UNITED STATES PATENT AND TRADEMARK OFFICE

APPLICATION NO.	FILING DATE	FIRST NAMED INVENTOR	ATTORNEY DOCKET NO.	CONFIRMATION NO.
09/882,703	06/14/2001	Heinrich Foltz		9610
7590 Anthony Matulewicz Matulewicz & Associates, P.C. 521 S. Broadway St. McAllen, TX 78539			EXAMINER TRAN, CHUC	
			ART UNIT 2821	PAPER NUMBER
			MAIL DATE 12/02/2011	DELIVERY MODE PAPER

Office Action Summary**Application No.**

DETAILED ACTION

FIG. 15

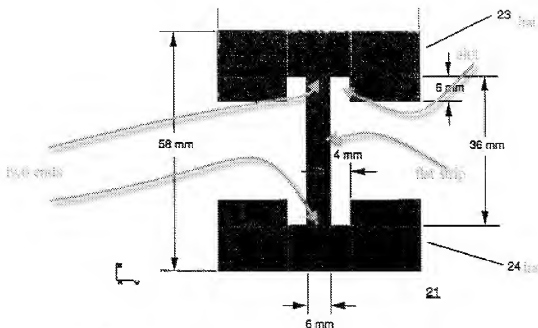
Regarding claim 3, Johnston et al disclose a parasitic reduce size printed dipole antenna element in Fig. 9-10 and 15, comprising: a dielectric substrate (8) (Fig. 9B, Col. 5, Line 43); two

conducting patches (sheet) (23, 24) one at each end of the dipole (Fig. 15, Col. 6, Line 11), a conducting strip (strip) (Col. 6, Line 13) narrower than the patches connected to said conducting patches (sheet) (23, 24) (See Fig. 15, below), forming a radiating part of the dipole element (Col. 3, Line 30), and a slot cut into said conducting patch (23, 24) (See Fig. 15, below).

length of said conductor (Fig. 3). However, Quade is silent on a limitation of said linear conductor having a first end and a second end. Johnston et al reference teaches in Fig. 15, said linear conductor (flat strip) having a first end and a second end (See Fig. 15 above). It would have obvious to incorporate the Johnston's teaching into the Quade's teaching for reducing the input impedance in order to improve the antenna elements.

conductor having a first end and a second end. Johnston et al reference teaches in Fig. 15, said linear conductor (flat strip) having a first end and a second end (See Fig. 15 above). It would have obvious to incorporate the Johnston's teaching into the Quade's teaching for reducing the input impedance in order to improve the antenna elements.

FIG. 20

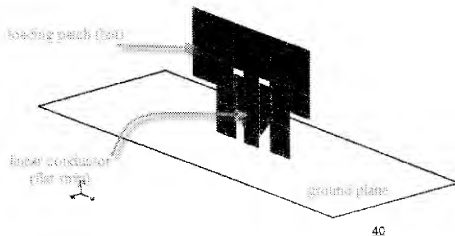
Regarding claim 4, Johnston et al disclose that one half of the dipole antenna (21) mounted on a ground plane (Fig. 20, below, Col. 6, Line 45-49).
